# US 1/SR 4 Widening and Oak Park Bypass

EDS-545(14)(17)(18) Toombs and Emanuel Counties

## Value Engineering Study Report Preliminary Design Stage

ALT MR-4  
 SHIT 2 of 2

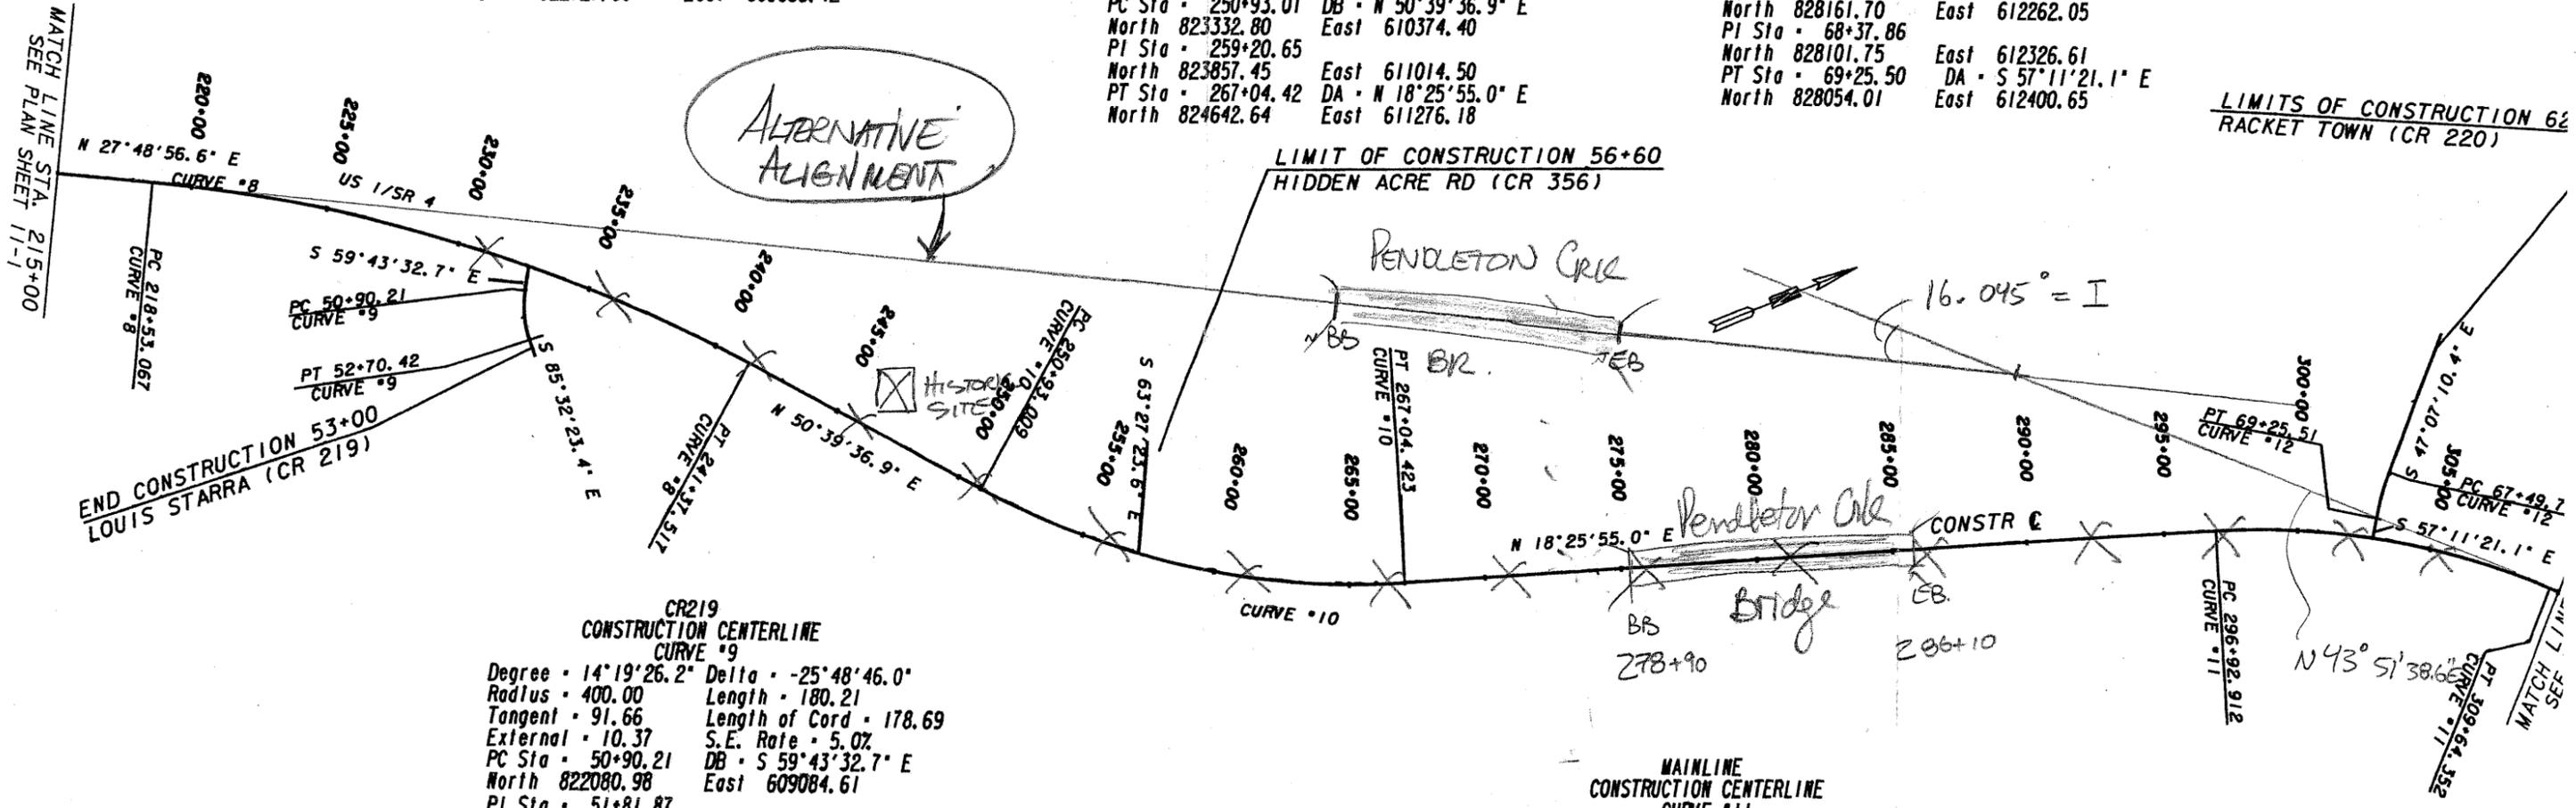
It appears that options for the alignment have been limited to going east of the historic property. The VE team believes that an alternative alignment west of the historic property should be entertained to avoid wetlands and provide a less curvy alignment.

DESCRIPTION: **TIGHTEN HORIZONTAL CURVE OF THE INDEPENDENT ALIGNMENT NEAR PINE LOG ROAD** SHEET NO.: **1 of 5**

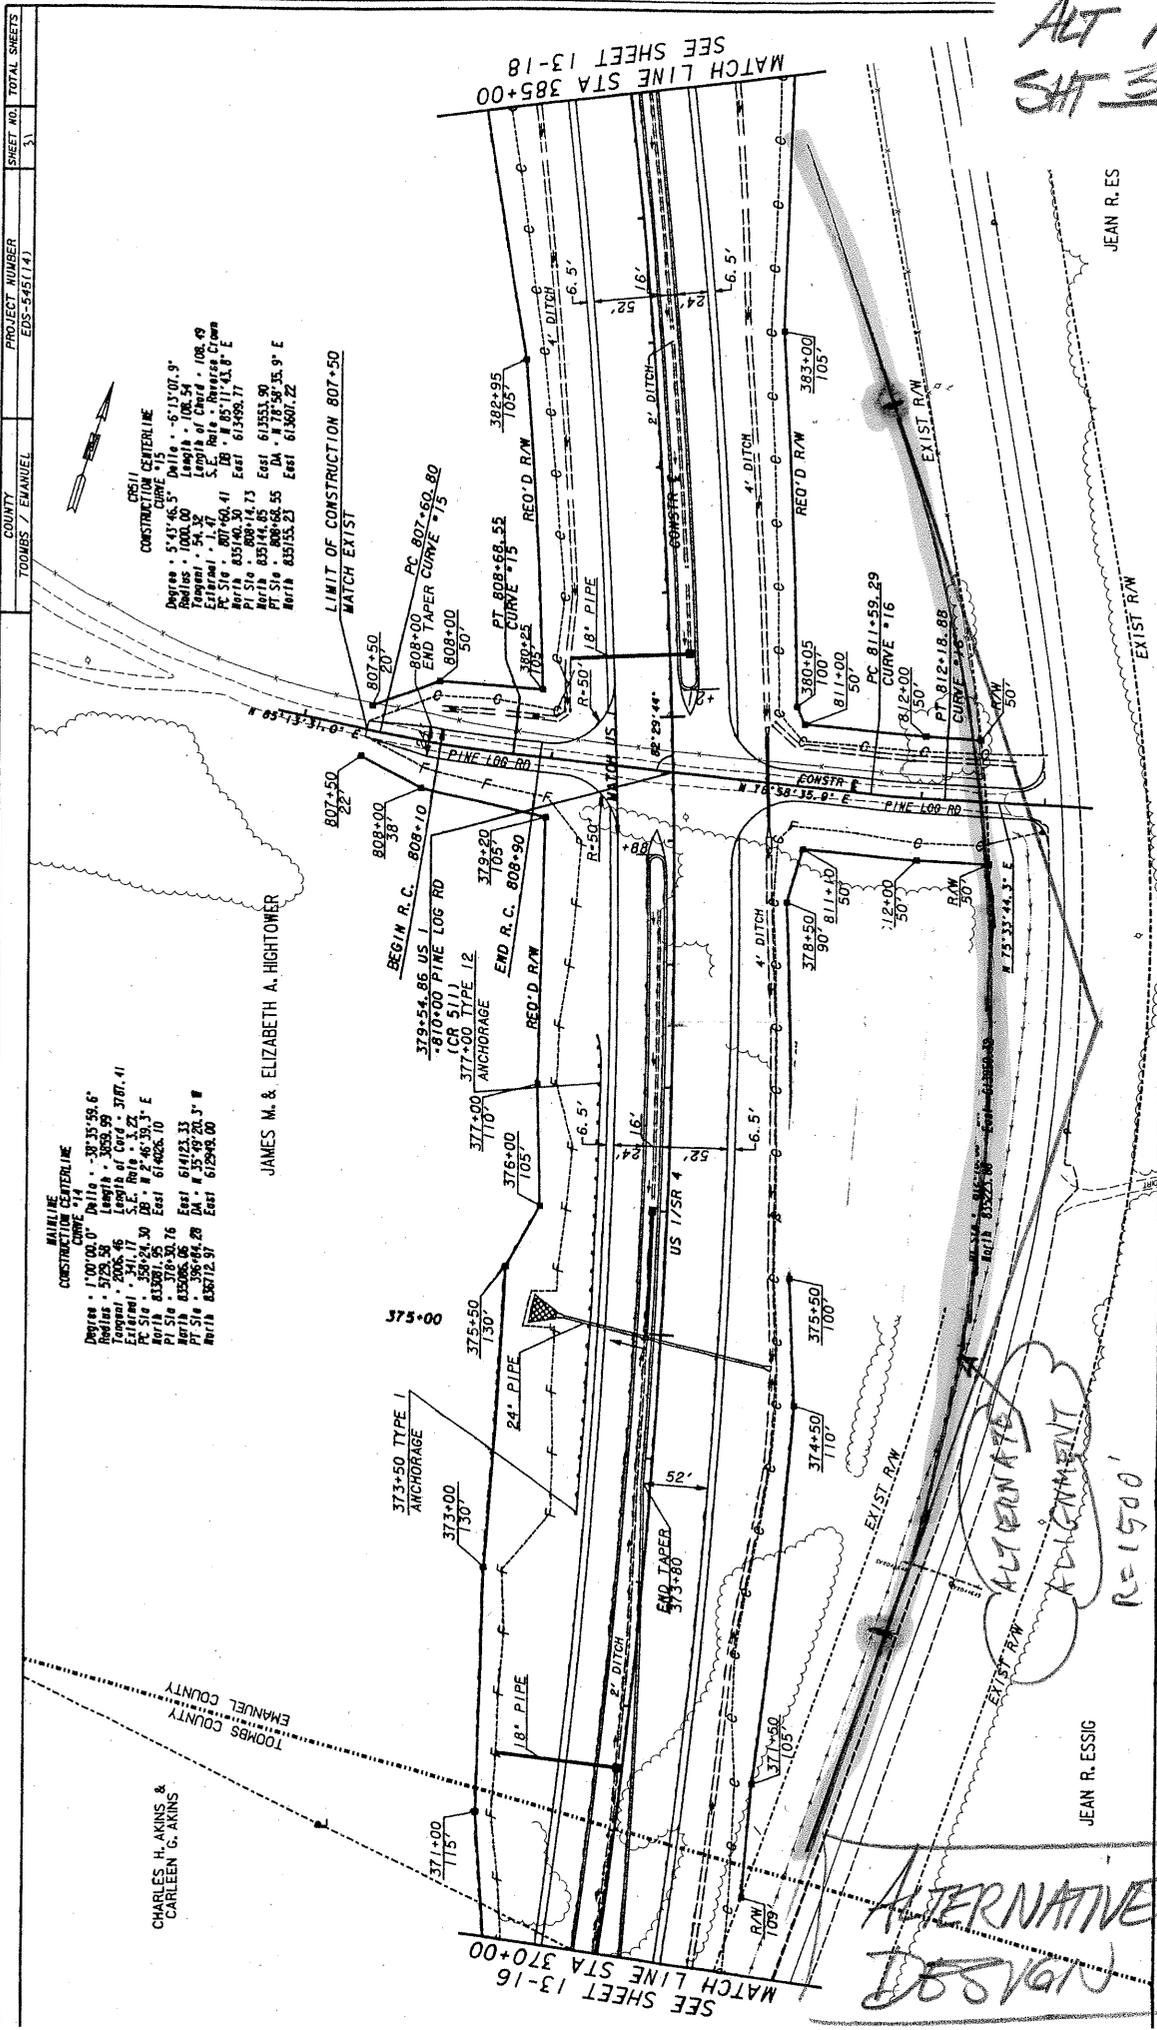
Reducing the curve radius shifts the alignment to almost on top of the existing alignment. This will reduce the need for fill as well as the purchase of new right-of-way.

ALTERNATIVE ALIGNMENT  
RADIUS = 3350'

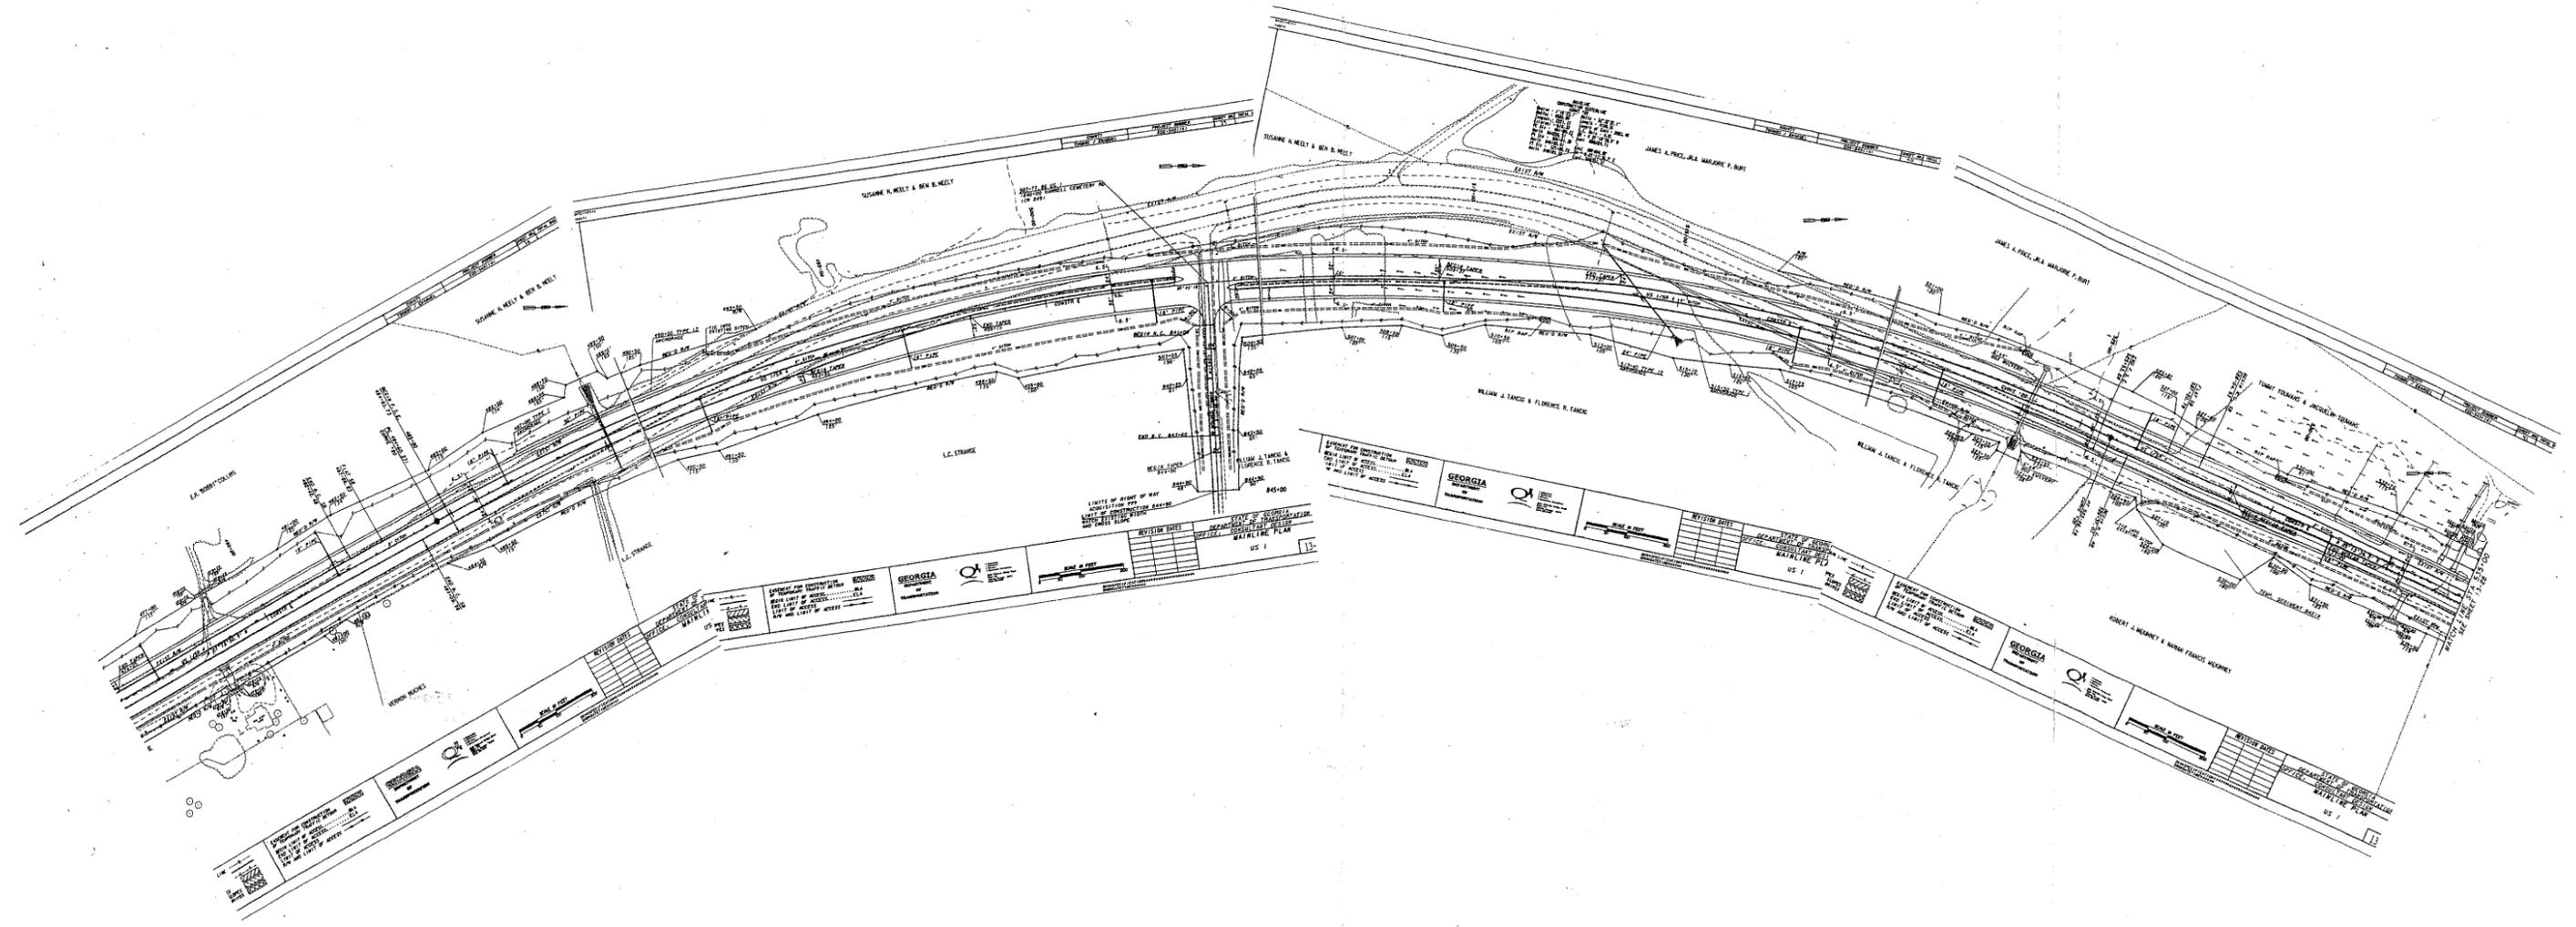
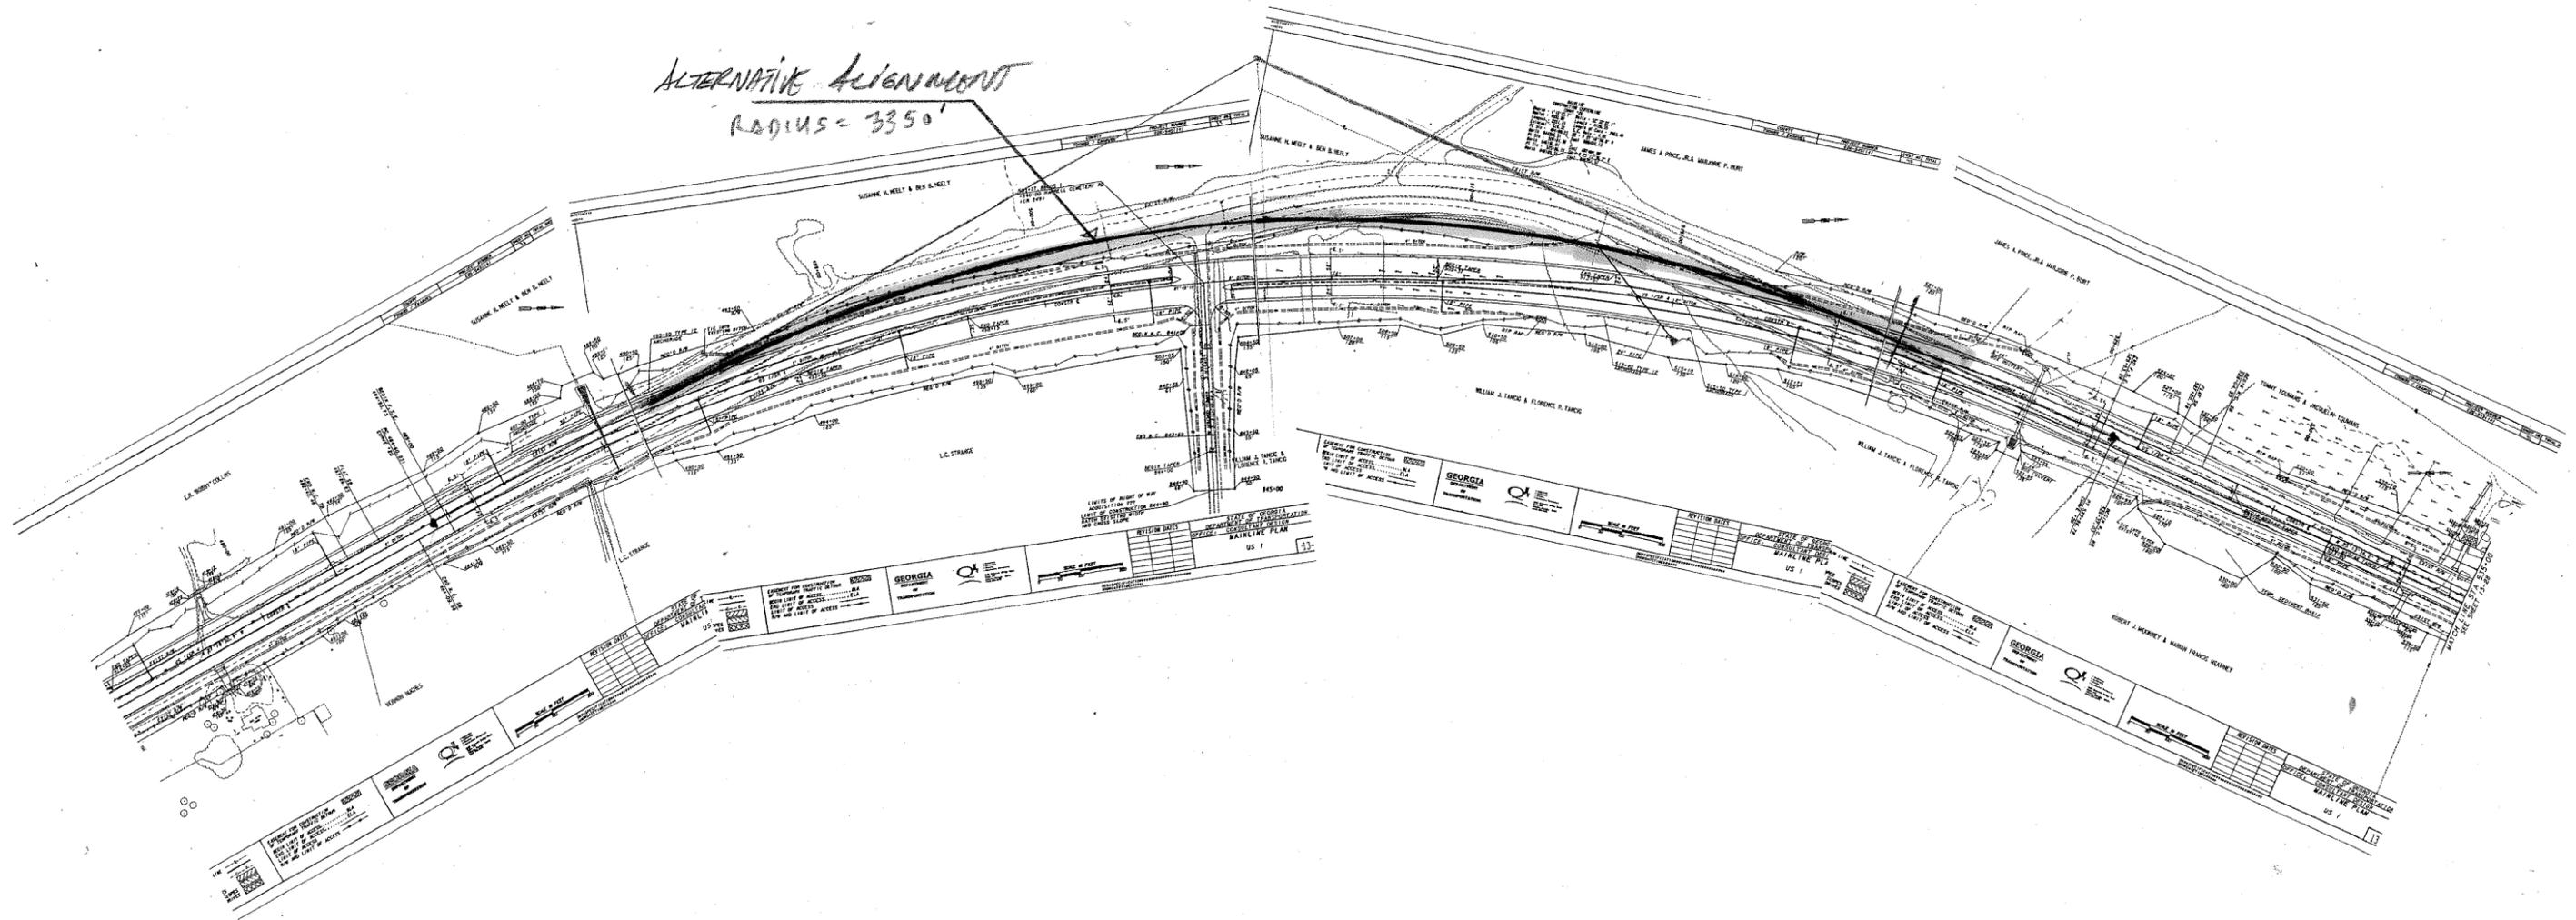
- Reduced curve length shifts the alignment closer to existing alignment
- Reduces costs by using existing roadbed
- Minimizes right-of-way takes

- Sharper curve with greater super-elevation rate
